**COUNTY OF ALBEMARLE
STAFF REPORT SUMMARY**

Project Name: ZMA201200007 5 th Street Commercial	Staff: Elaine Echols
Planning Commission Public Hearing: March 15, 2016	Board of Supervisors Public Hearing: TBD
Owner: FTV Investments	Applicant: Katurah Roell
Acreage: 4.35 acres	Rezoning: Modify plan and proffers for property zoned HC Highway Commercial and LI Light Industrial
TMPS: 0.875 acre portion of 07600-00-00-055A0, 3.041 acre portion of 076M1-00-00-00100, and all of 07600-00-00-055C0	By-right use: Proffers restrict the use to hotels, motels, restaurants, service stations, convenience stores, and gift, craft, or antique shops according to the proffered plan; a proffered plan shows the limits of development, reflecting a special use permit for fill in the floodplain
Magisterial District: Scottsville	Proffers: Yes
Proposal: Request to amend proffers and application plan of ZMA199900013 for 4.35 acres on property zoned HC – Highway Commercial, which allows commercial and service; residential by special use permit (15 units/ acre) and property zoned LI Light Industrial, which allows – industrial, office, and limited commercial uses (no residential use). No zoning district change an

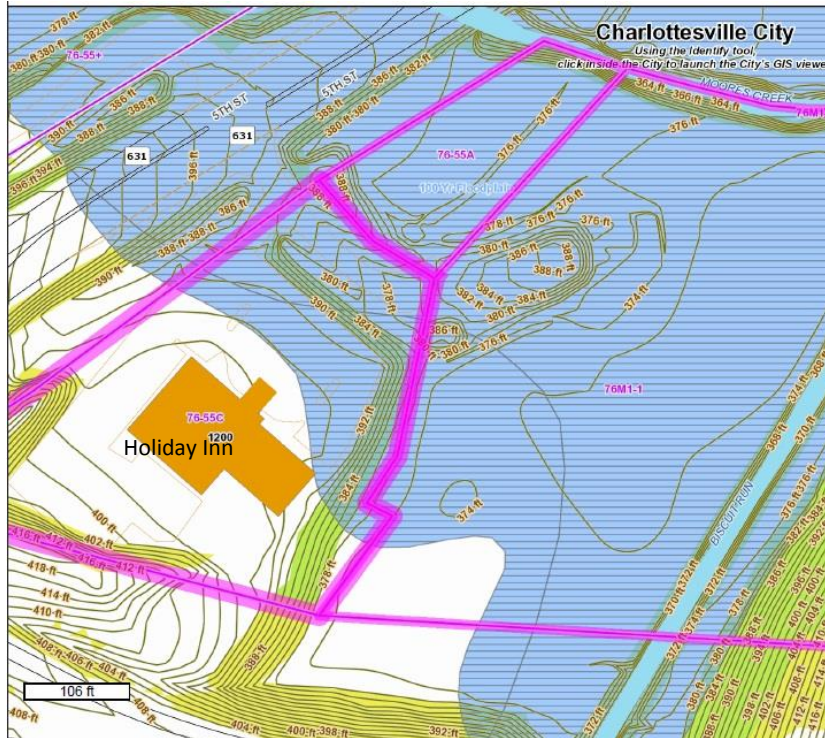
- 1. Please have the application show the current floodplain limits according to FEMA mapping. The proposed line or Conditional letter of Map Revision (CLOMR) lines do not appear to be the current regulatory limits.*

2. Please have the applicant clarify the limits of floodplain fill in the context of the previous approval. It appears that the proposed retaining wall may encroach further than the slope shown on previous concept plans. This would increase the proposed fill.
3. Please correct the buffer designation on the plan, and clarify the encroachment into the stream buffers. There is no 50' buffer in the WPO. There is only a 100' buffer. Up to 50' of encroachment and disturbance is permitted with mitigation. This should be compared to what was previously approved.

The image on the left shows both the floodplain and preserved slopes. Preserved slopes have been proposed for disturbance at the entrance and behind the Holiday Inn. Disturbances in both of these areas were approved in prior ZMA and SP approvals according to the plans.
